• • ADDENDUM # 2 ••

**PROJECT NUMBER: 130012-59
EASTERN REGIONAL WATER RECLAMATION FACILITY
OPERATIONS BUILDING RENOVATION
DUE DATE: 08/27/2025 @ 1:30 PM**

**EASTERN REGIONAL WATER RECLAMATION FACILITY
OPERATIONS BUILDING RENOVATION
PROJECT NO. 130012-59**

**CHANGES TO BID DOCUMENTS – SPECIFICATIONS AND CONTRACT
DOCUMENTS**

9 DET - HD @ RATED CMU PARTITION TYP

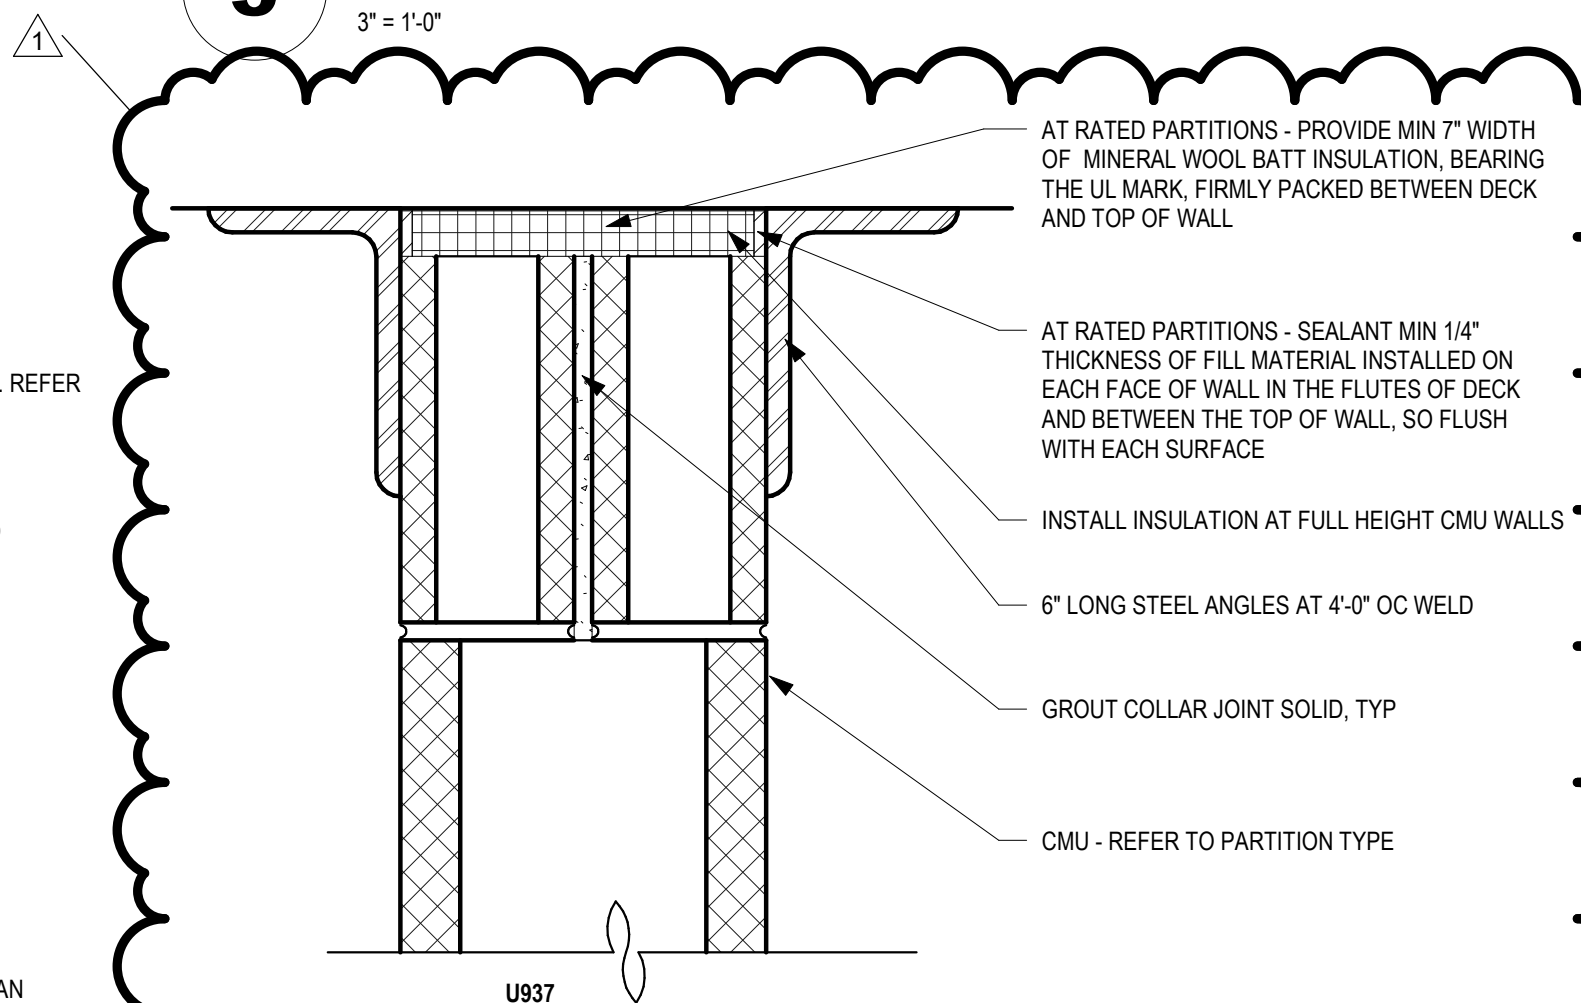
- c. Add detail 9/A-520 per attached sheet.
11. Sheet A-601 DOOR SCHEDULE, TYPES & DETAILS
- a. FIRST FLOOR DOOR SCHEDULE:
 - i. Revise label to 45 MIN for doors 113-3 & 116-1 per attached sheet.

HVAC GENERAL NOTES, SYMBOLS, & ABBREVIATIONS

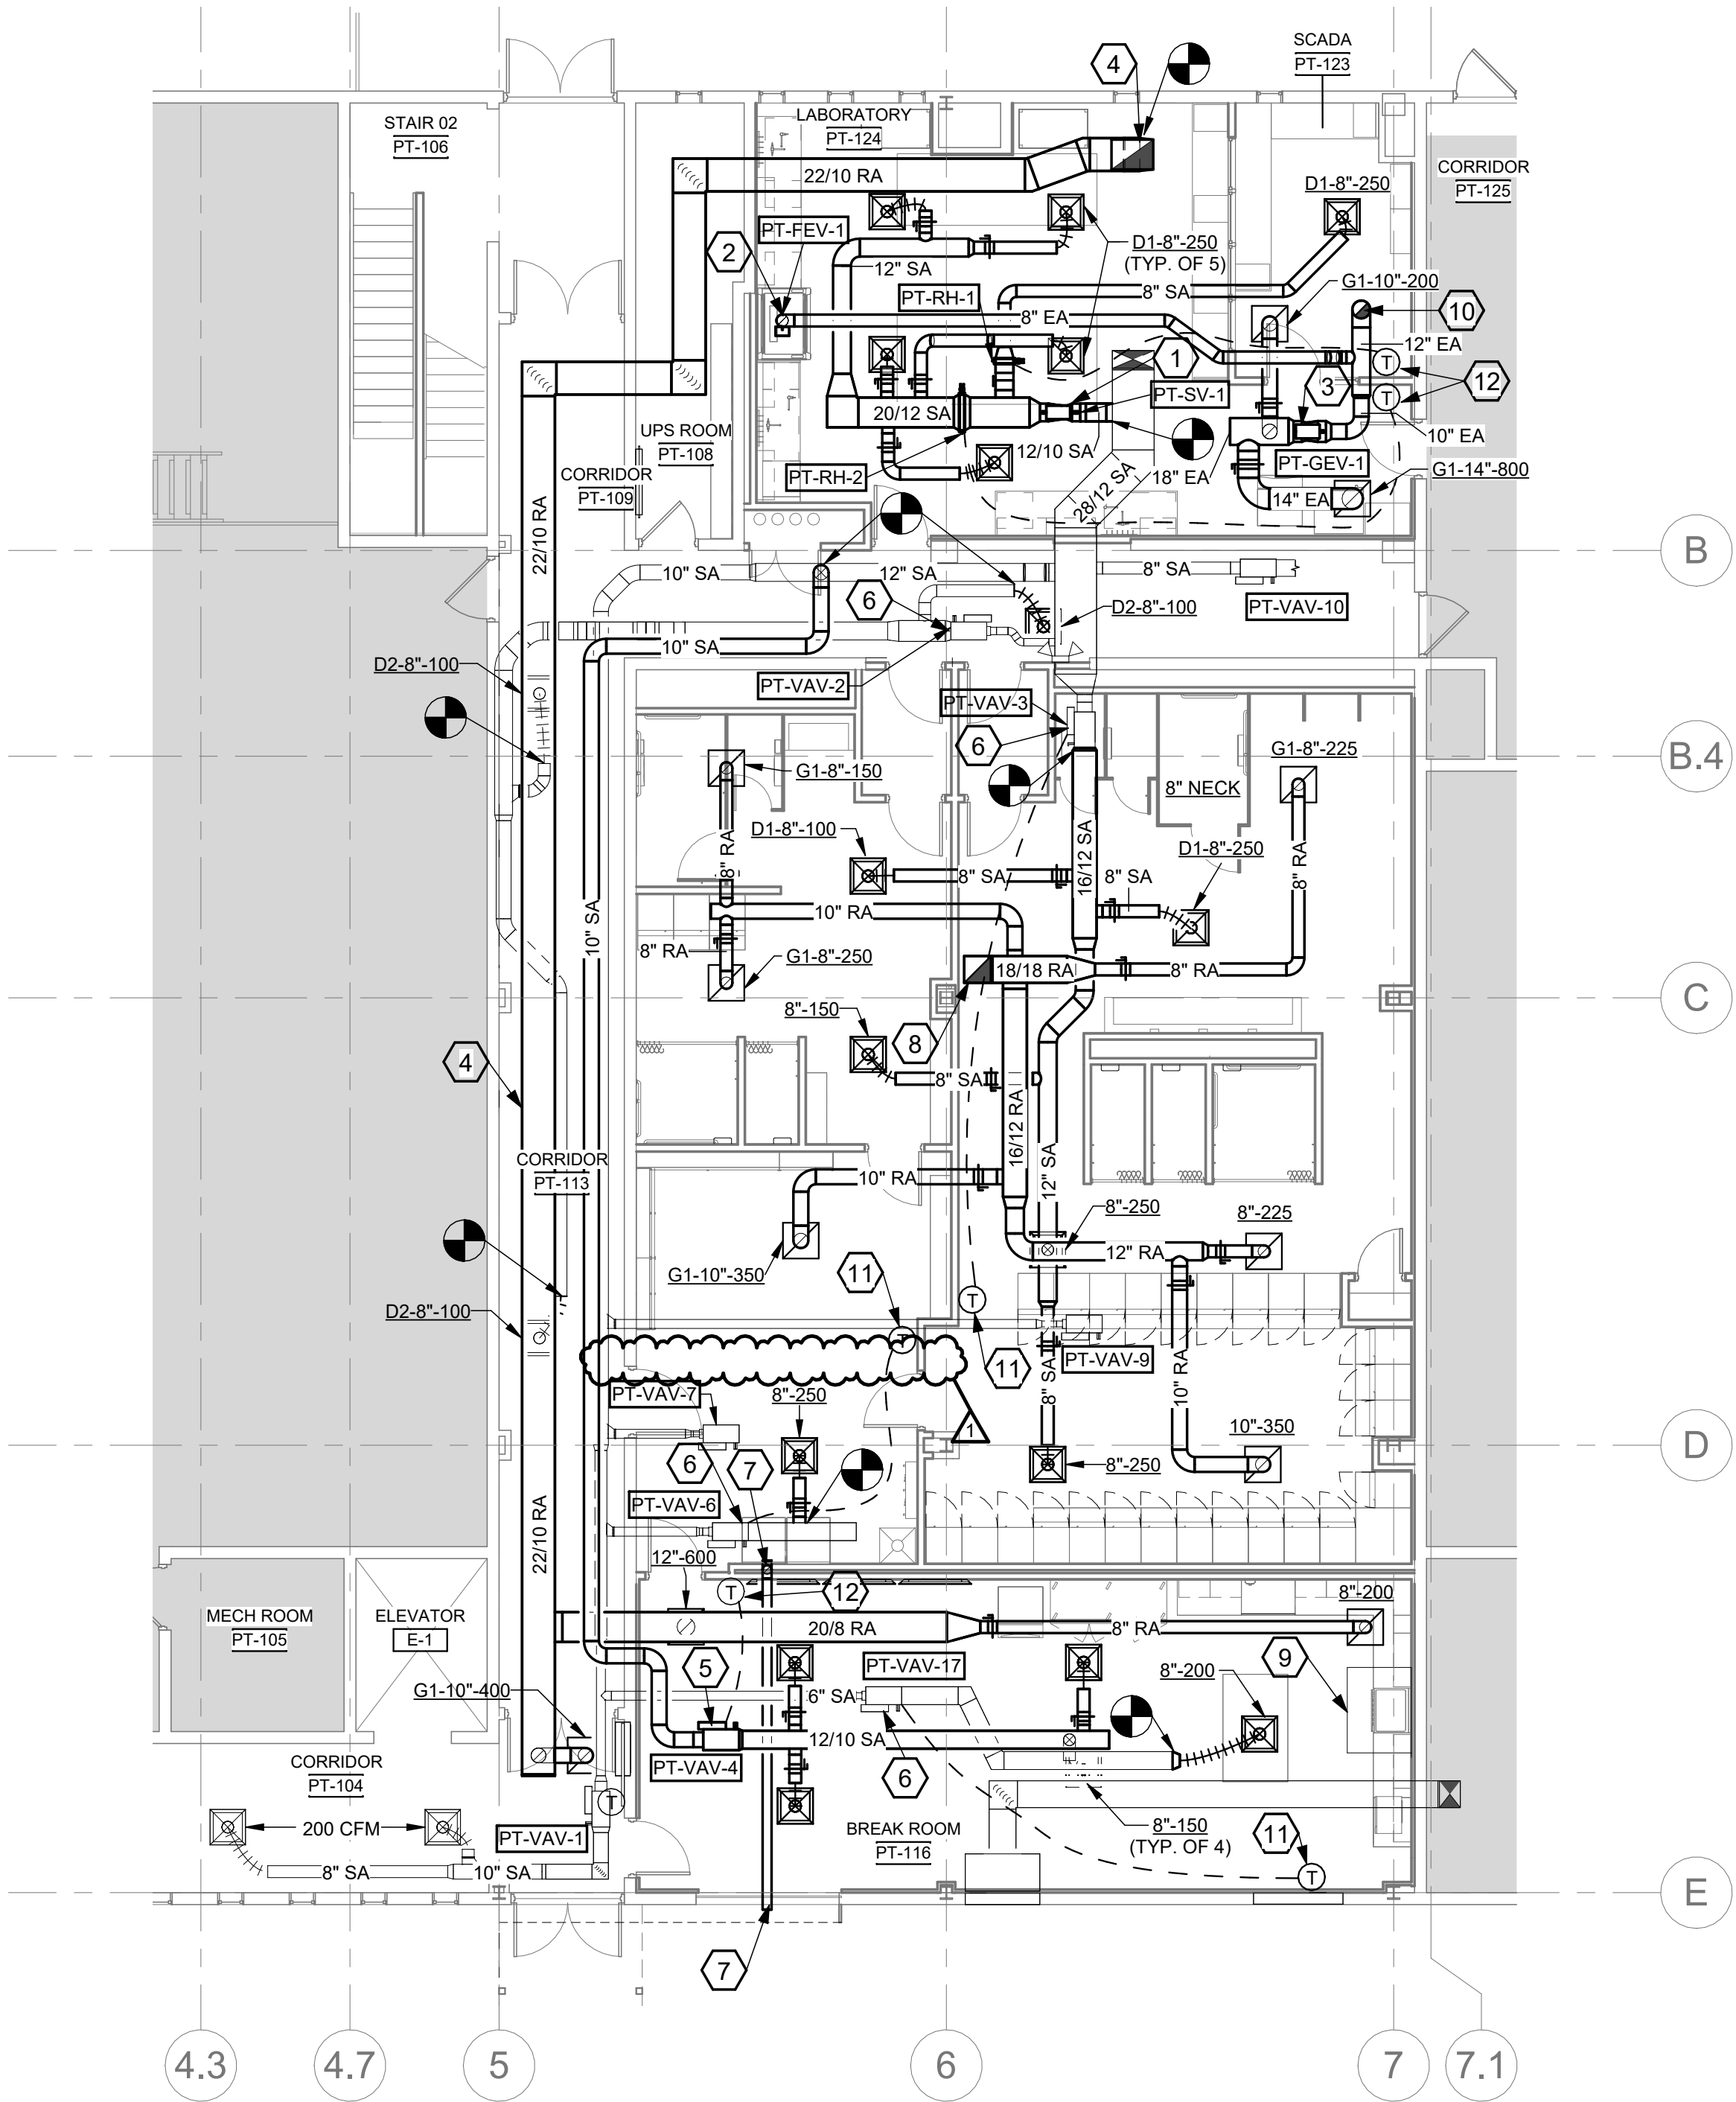
- a. Add fire-stopping details for piping and round ductwork for 1-hour rated walls.
13. Sheet M-200 HVAC FIRST FLOOR NEW WORK PLAN
- a. Show VAV box PT-VAV-8 as being removed.

- A. Study – Wall framing shall consist of channel studs. Steel studs will be min 3-1/2 in. (89 mm) wide and spaced max 24 in. (610 mm) OC.
 - B. Wallboard, Gypsum* – 5/8 in. (16 mm) thick, 4 & (122 cm) wide square or tapered edges. The gypsum board type, thickness, number of layers, fastener type and sheet orientation shall be as specified in the individual Wall and Partition Design in the UL Fire Resistance Directory. Maximum depth of opening is 24 in. (610 mm).The hourly F and FT Ratings of the freestop system are equal to the hourly fire rating of the wall assembly in which it is installed.

- A. Spiral Wound HVAC Duct – Nom 20 in. (508 mm) diam (or smaller) No. 24 MSG (or heavier) galv sheet spiral wound duct.
 - B. Sheet Metal Duct – Nom 12 in. (305 mm) diam (or smaller) No. 28 MSG (or heavier) galv sheet steel duct.

HVAC FIRST FLOOR NEW WORK PLAN
**Eastern Regional Water
Reclamation Facility Operations
Building Renovation**

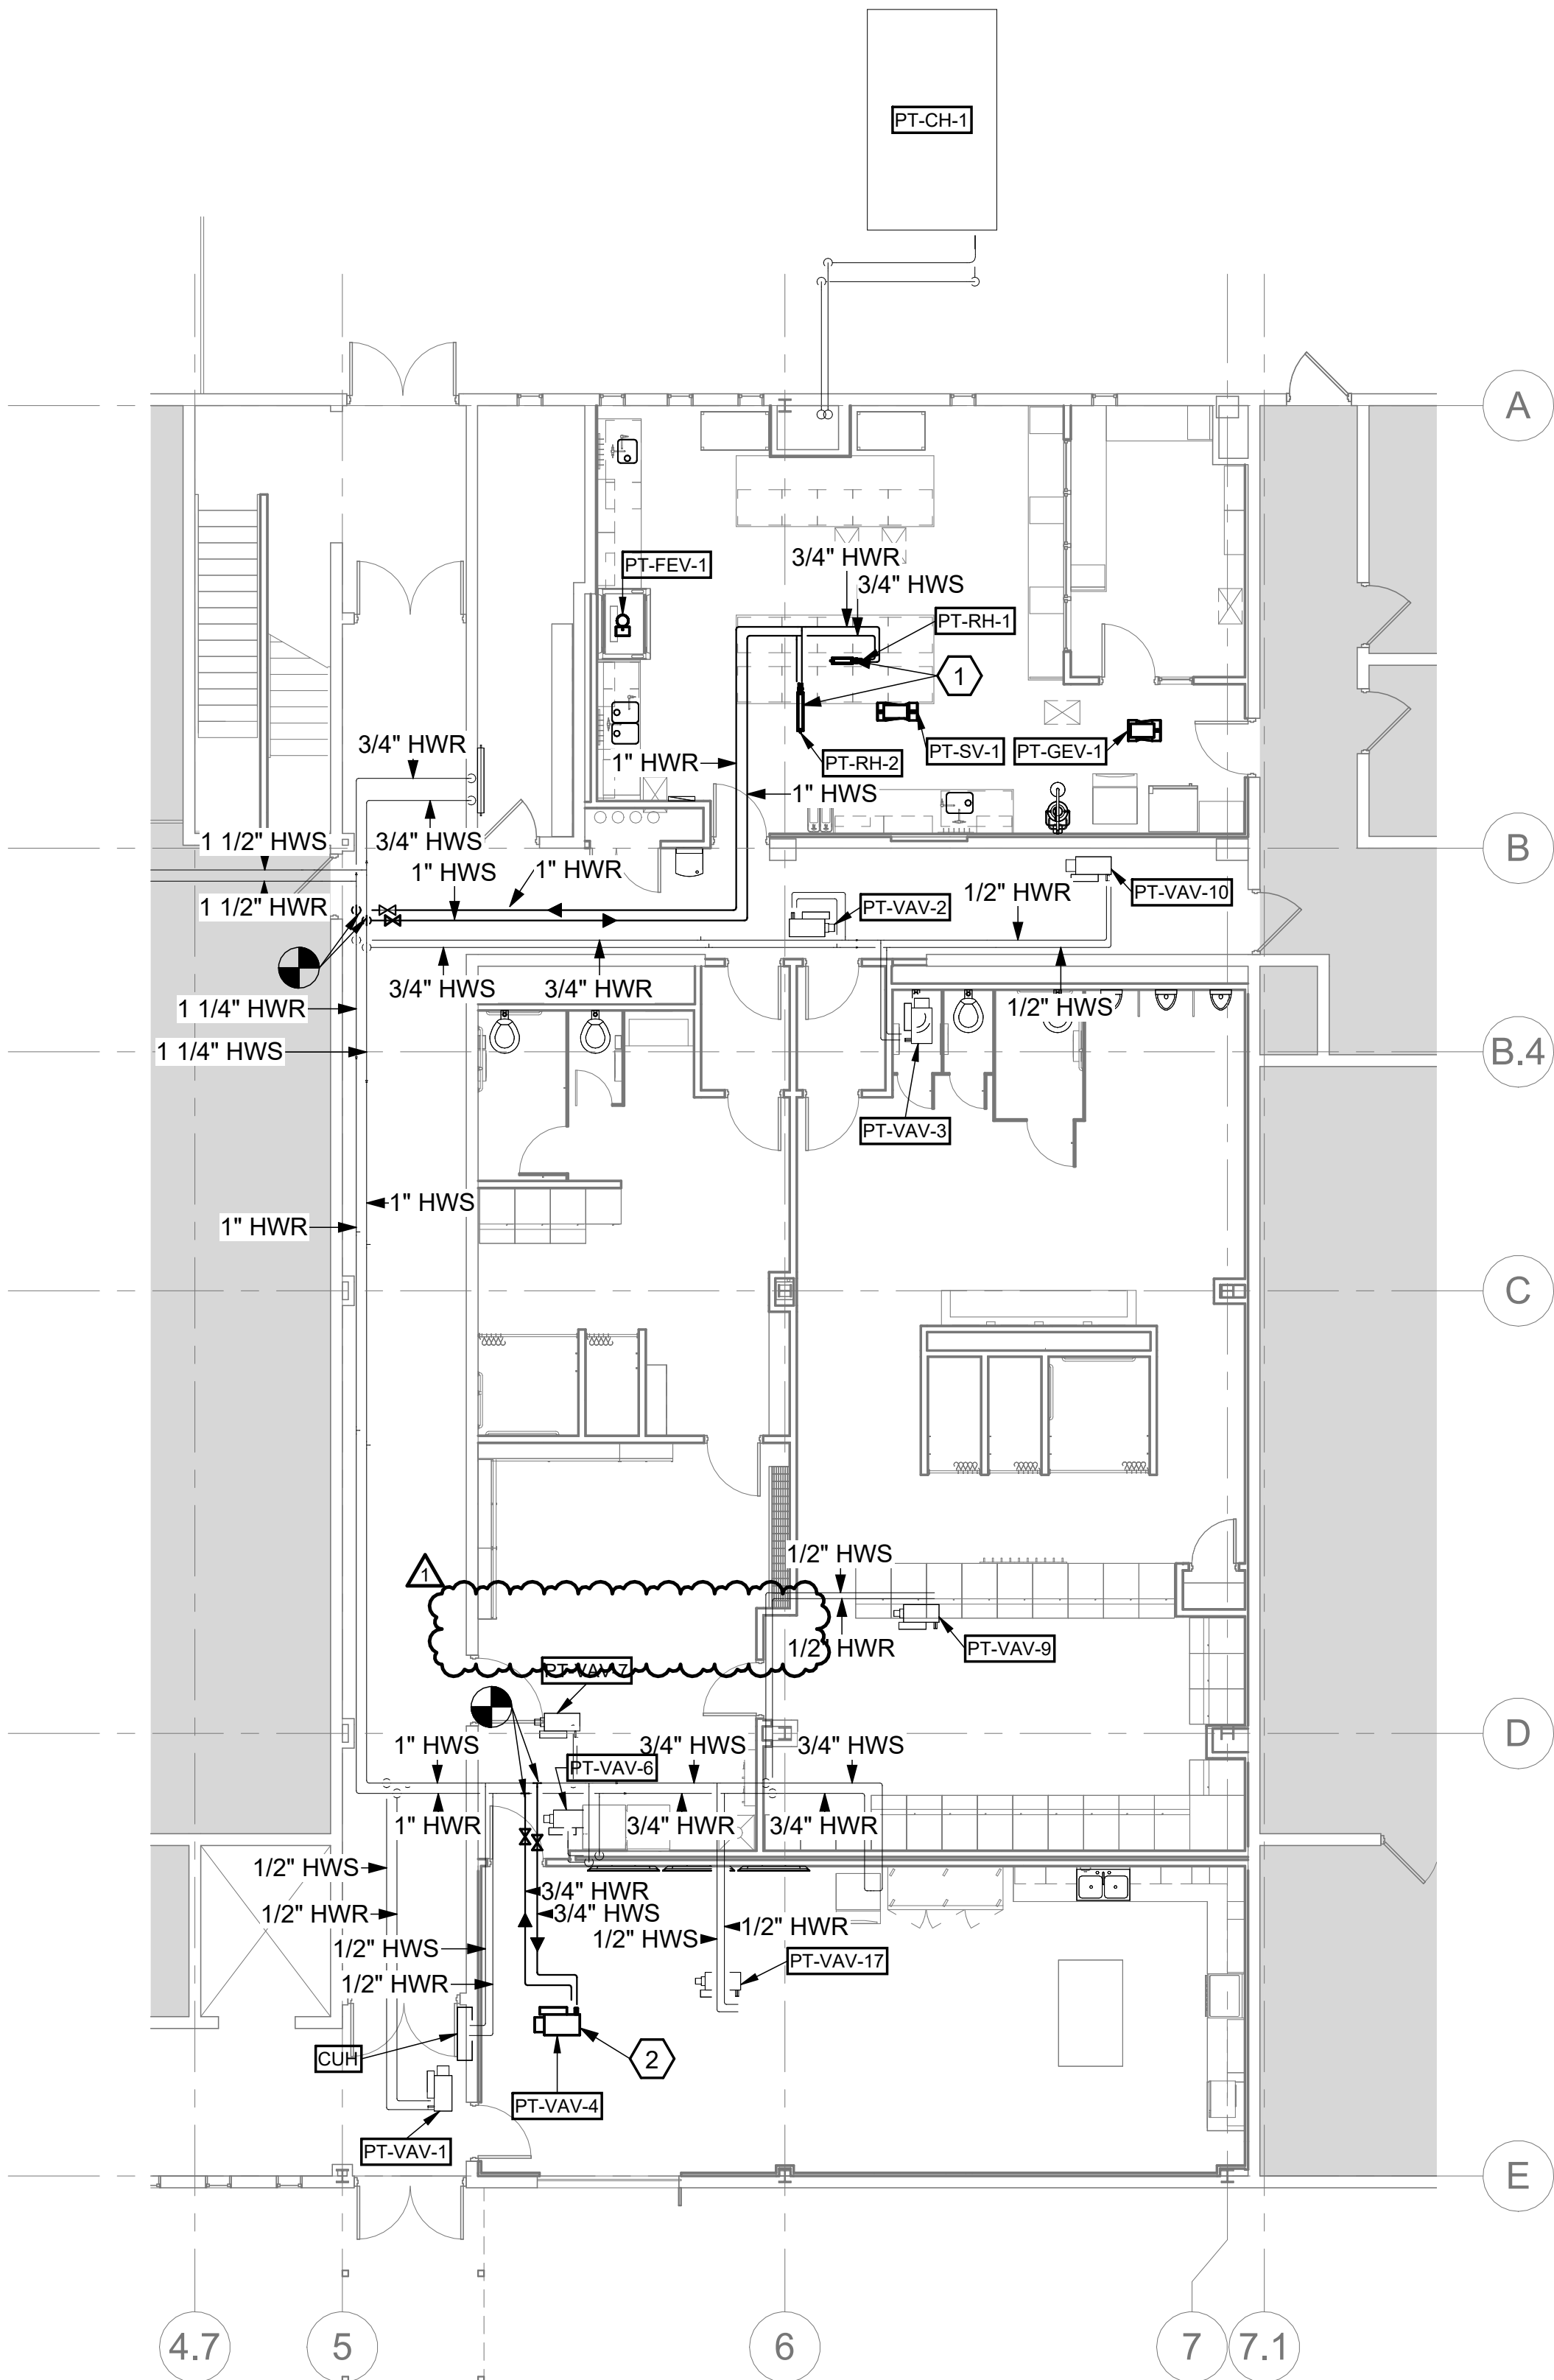
- b. Per OMC 607.5.3, exception 4, a fire damper is not required in the 1-hour fire partition wall for room PT-120 from the 10" exhaust air duct.
14. Sheet M-201 HVAC PIPING FIRST FLOOR NEW WORK PLAN
